# **PREDETERMINATION SETTLEMENT AGREEMENT**

CP# 09-16-69571  
HUD# 07-17-5069-8

Lake Shore 1 consists of a residential-unit building located at 902 East 1<sup>st</sup> Street. The building was issued a Certificate of Occupancy on May 25, 2016, signed by Jeff Junker, Building & Zoning Administrator for the City of Ankeny. According to Respondents, two additional dwelling-unit buildings and common areas are under construction at 458 NE Delaware Avenue (“Lake Shore 2), and at 305 NE Hayes Drive (“Lake Shore 3”).<sup>2</sup> Currently, there are 85 dwelling-units. Once all three dwelling-unit buildings are built, it is expected that there will be a total of 239 units from all three buildings, as all the units in each building are served by an elevator. Each of the three dwelling-unit buildings and common areas will be required to meet the same accessibility requirements of the ICRA and FHA, and are therefore included within the scope of the current agreement.

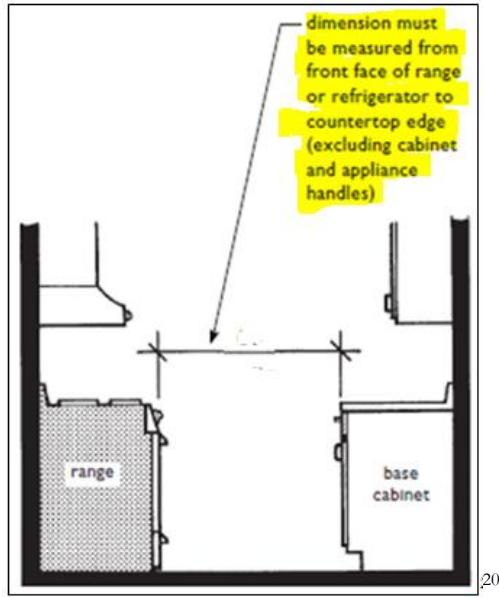
(a) The parties agree the U-shape kitchen in Unit 328 (Okoboji) has insufficient clear floor space because the turning space diameter in front of the refrigerator is less than the 60-inch minimum that is required by the Manual when a range is located at the bottom of the U-shape kitchen.

- i. Replace the refrigerator with a different model that has a depth of at least 3 inches less than the current refrigerator;
- ii. Move the refrigerator closer to the wall behind it;
- iii. Recess the plastic water pipe connection from the rear of the refrigerator further into the wall behind the refrigerator, to be followed by moving the refrigerator closer to the wall behind it.

(c) Respondents agree to measure the clear width of the path as indicated in the figure below:

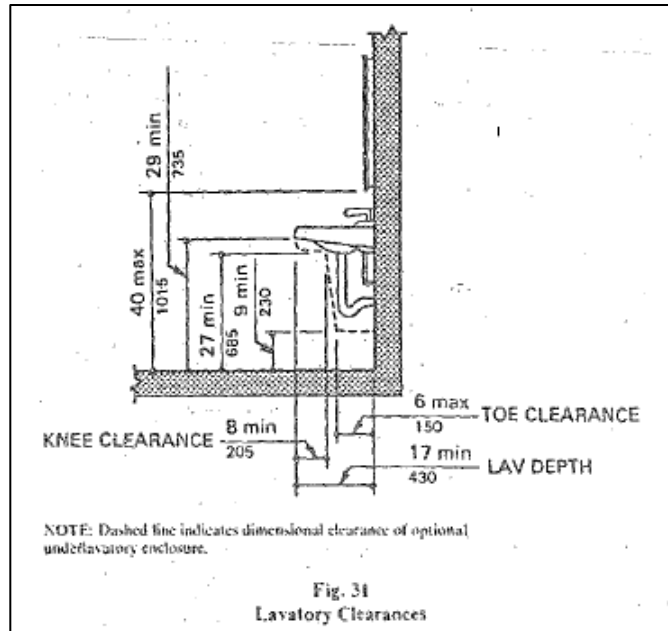
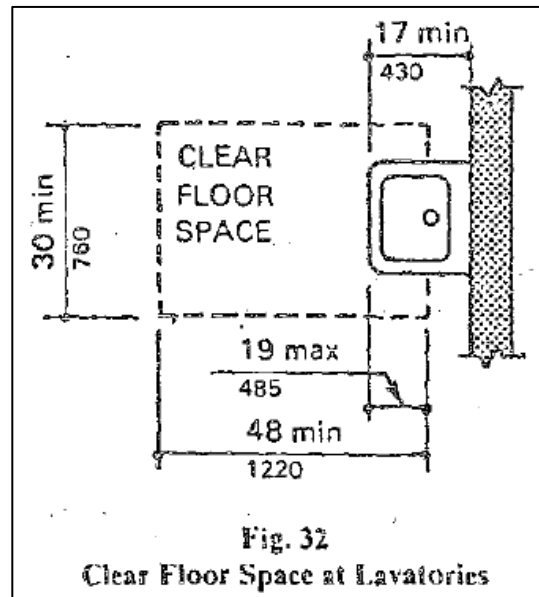
- (a) The parties agree the distance from the midline of the sink to the closest opposing countertop in the kitchens of Units 117 (Rathbun), 231 (Ozarks), and 423 (Panorama), as reported on page 6 of the current agreement, was measured at under the 24-inch minimum for kitchen sinks without removable cabinets, as required by the Manual.

- (b) Respondents agree to retrofit the kitchen sinks in the inspected units listed in “(a)” paragraph in Lake Shore 1, by (i) replacing the base cabinets with removable cabinets; and (ii) by finishing all unfinished surfaces if the removable cabinet needs to be removed – which includes flooring vinyl tiles of the closest possible design as the existing flooring, cabinet surfaces of the same design, and painted walls if exposed – such that the dimensions of the space created once the removable base cabinet is removed for a tenant in a wheelchair, meet the “knee clearance” requirements from ANSI 1986, as indicated in the figures at the top of the next page.

(c) Respondents agree to install removable base cabinets under the kitchen sinks of the Ozarks and Panorama Units in Lake Shore 2 and 3, in the manner described in “(b)” paragraph above.
